Confused by the brochure and questionnaire?

Our guide to some of the issues . . .

NEWSLETTER #18

This is what is proposed in the brochure

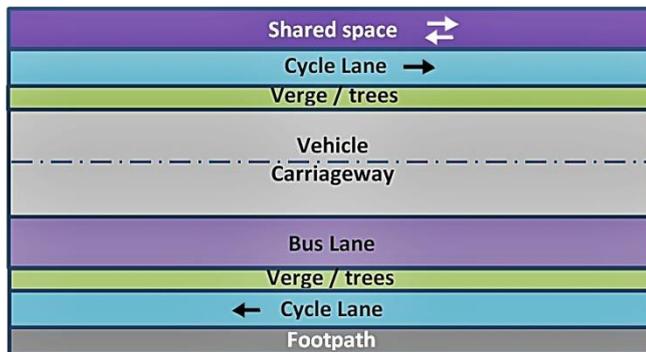
We believe that the pavements should be pedestrian only and that cycleways should always be segregated from footways. Not only would a shared-use pavement be unsafe and intimidating for vulnerable pedestrians, it would also encourage people to cycle in

close proximity to the many driveways on the north-west side of Milton Road leading to an increased risk of collision with vehicles exiting from driveways.

If the 1.4 km path on the north-west side is designated as shared-space it will mean that cyclists will have multiple choices within the law for their journey – the segregated cycle lanes, the shared-space path or the vehicle carriageways. By contrast, the choice for pedestrians and vulnerable users is bleak – either negotiate the shared-use path on one side of the road or cross over to the footpath on the far side.

In the section from the roundabout to Ascham Road it is expected that the pedestrian footpath would be up to 3m wide – enough space for children to use at the beginning and end of the school day.
